Intel[®] 81348 I/O Processor

Specification Update

May 2012

Order Number: 315041-009US

Figure 8. VCC1P2PLLS0, VCC1P2PLLS1 Low-Pass Filter

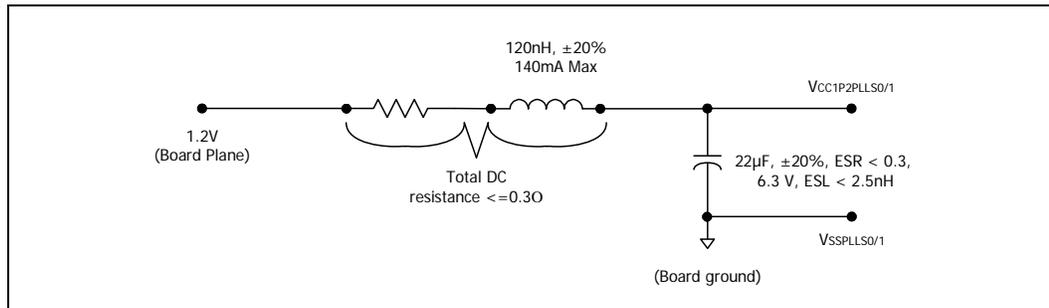
Problem: The VCCPLL Pin Requirements section of the Datasheet have changed. See below for the updates in Section 4.1 and Figure 8 in the Datasheet.

This paragraph pertains to the VCC1P2PLLS0, VCC1P2PLLS1 filters. The recommended filter for the PLL supplies is shown in Figure 8. The purpose of this filter is to achieve at least 10 dB rejection of frequencies between 1 and 20 MHz. The board supply distribution system must ensure that the minimum voltage into the PLL ball is equal to or greater than 1.164 V. The current draw for the IC is 95 mA typical less than 140 mA maximum. The filter components are selected to achieve a corner frequency of 100 KHz. The series resistance keeps the Q of this resonant circuit safely below unity for all component variations. The total DC resistance of the resistor and the inductor must be equal to or less than 0.3 Ohms.

The bypass capacitor must be placed as close to the supply pins as possible. The series impedances to both the supply pin and the PCB analog ground plane must be an order of magnitude lower than the ESR and ESL specified for the capacitor. The S0/S1 PLLs have dedicated internal supplies, so the VSSPLLS0/S1 pins must be soldered directly to the analog ground plane of the PCB.

New Figure 8:
